HOUSTON CONSTRUCTION CODE MODERNIZATION

**SIGNIFICANT CODE CHANGES &
HIGHLIGHTS OF THE 2015 TO 2018 AND
2018 TO 2021 INTERNATIONAL
RESIDENTIAL CODE (IRC)**

Significant changes to base code requirements from 2015 to 2018 and 2018 to 2021

Changes and updates to City of Houston amendments

Table
R703.8.4(1)

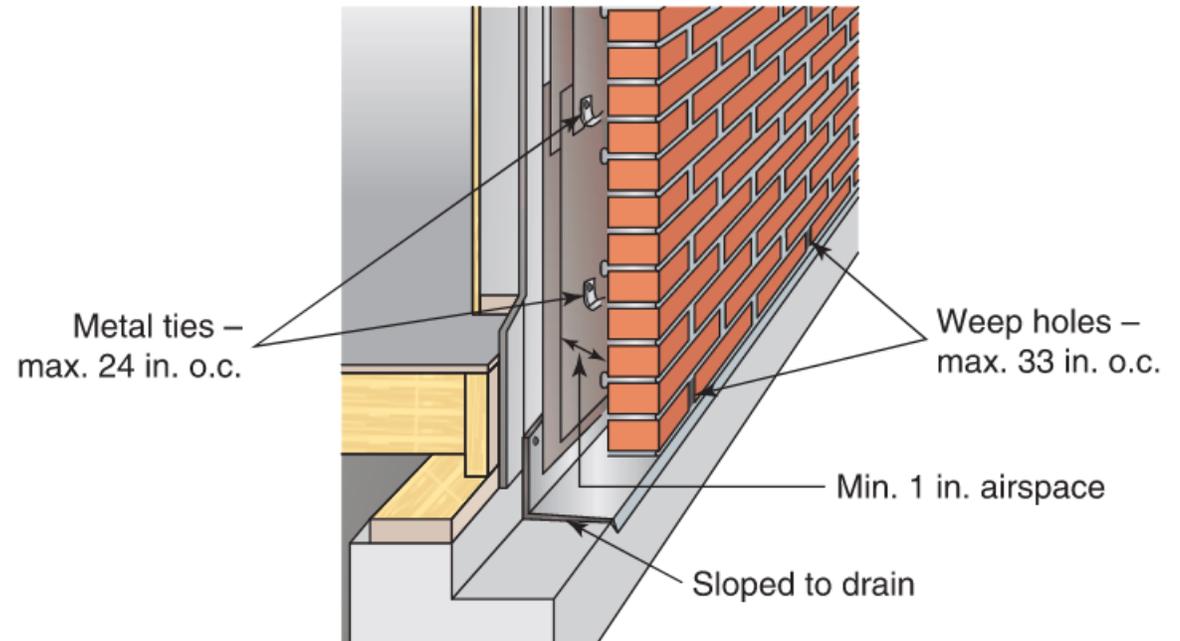
- Added footnote to Table R703.8.4(1): “An airspace that provides drainage shall be permitted to contain mortar from construction”

Minimum Vent Area

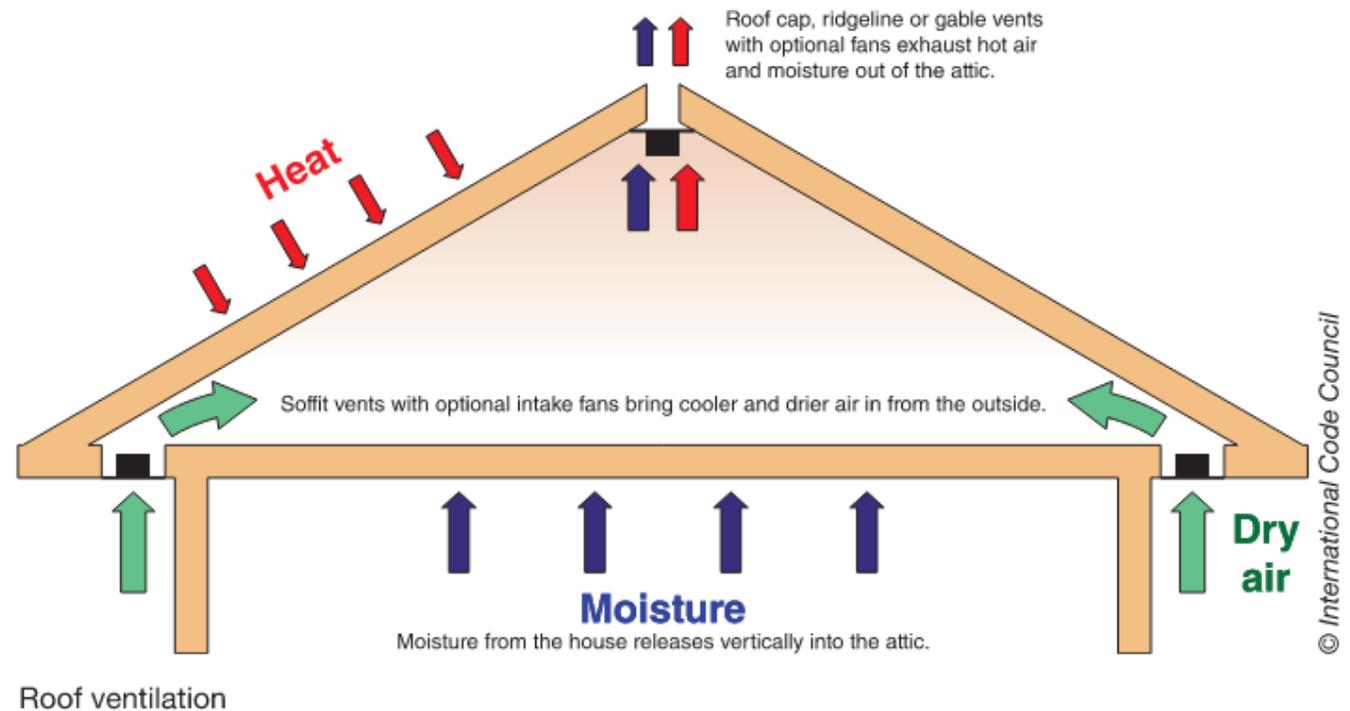
- Item 5.2 is added as an alternative path for un-vented attics and rafter assemblies to the requirements of Item 5.1. The new option is limited to warm climates and has 10 requirements to address in the installation of air-permeable insulation.

Definition of Air Barrier

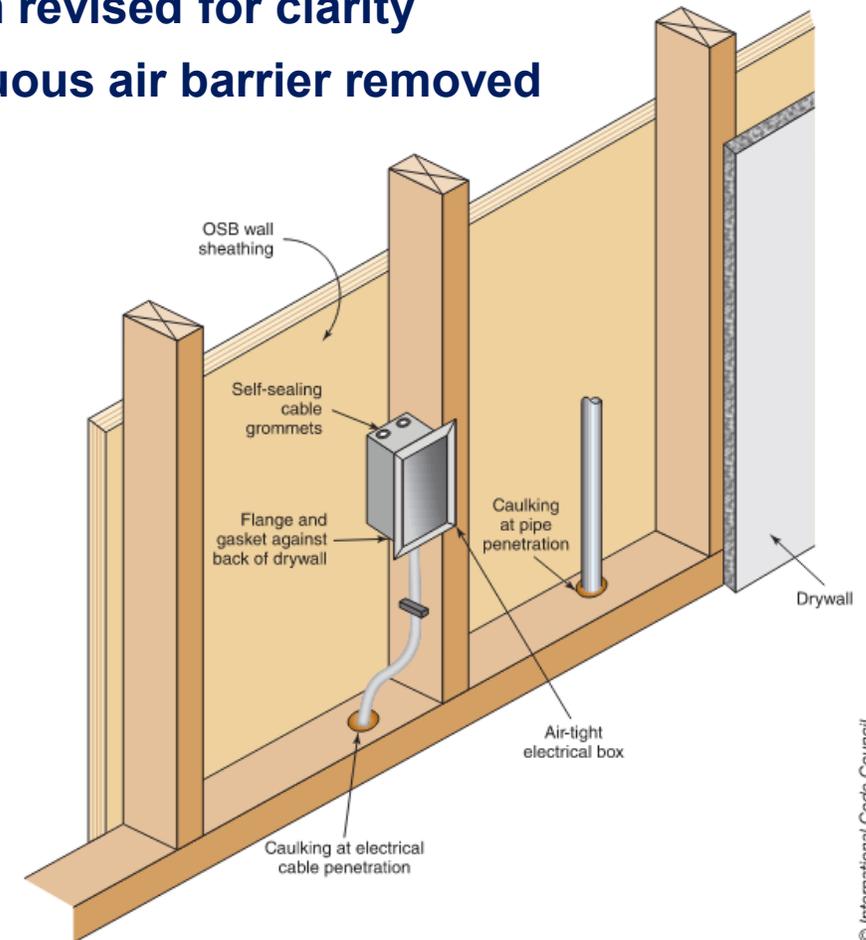
- Air barrier definition revised for clarity
- Definition of continuous air barrier removed

Definition of Building Thermal Envelope

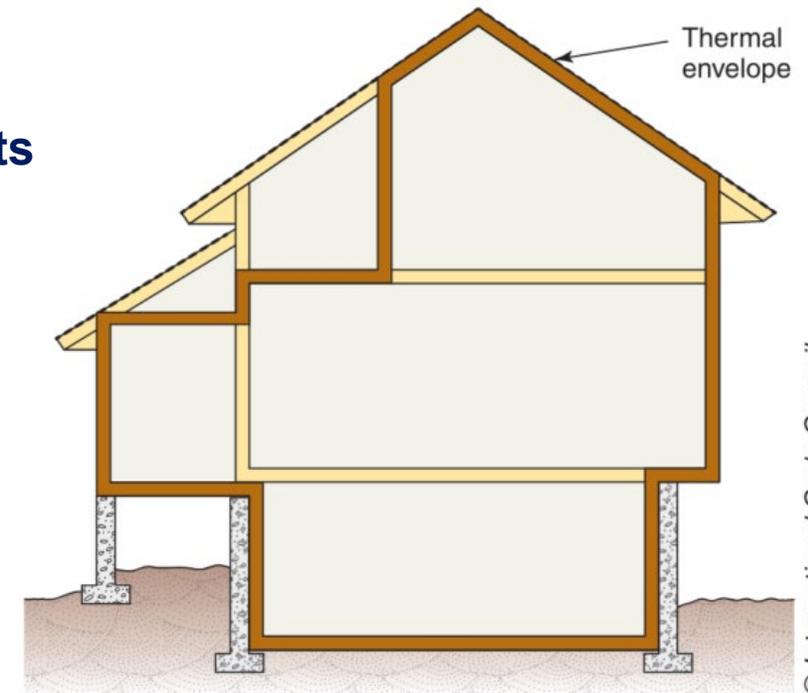
Revised definition of building thermal envelope

- Ceilings now added to included elements
- Any other building elements
→ any other building element assemblies

Reduction of Ceiling Insulation

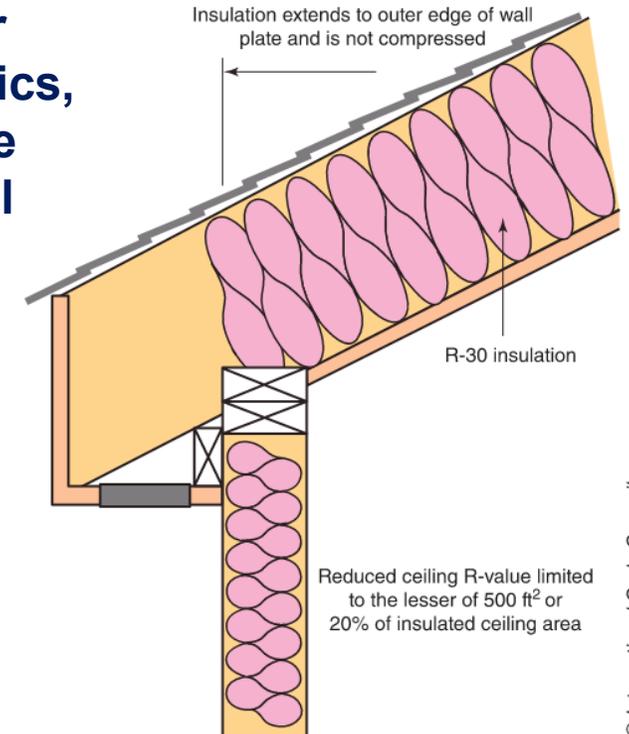
Modification to exception for insulation in ceilings without attic spaces

Electrical Bonding of CSST

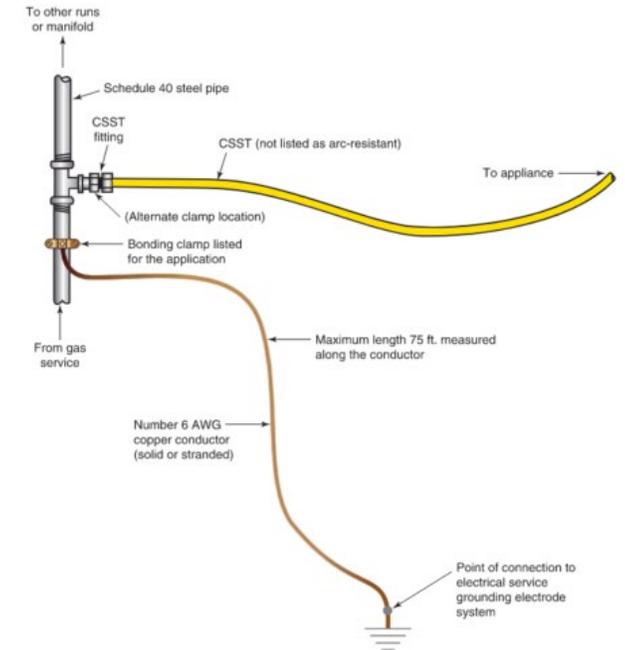
Modifies existing provisions for electrical bonding

Light Straw-Clay Construction

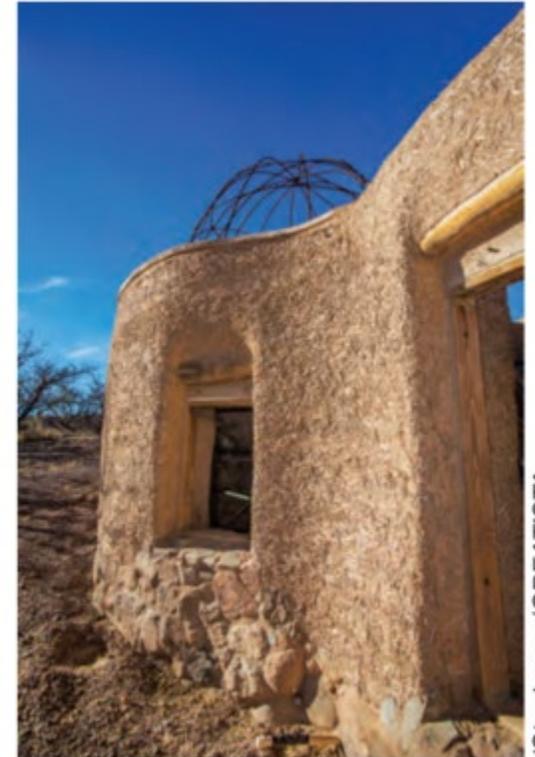
- Lateral bracing at light straw-clay infill must be Method Let-In-Brace and solid sheathing not allowed
- New Table AR103.2.3: Requirements and Properties of Light Straw-Clay Mixtures
 - Describes required properties and components of light straw-clay mixtures at various densities
- Language change: Reinforcement → Stabilization of light straw-clay
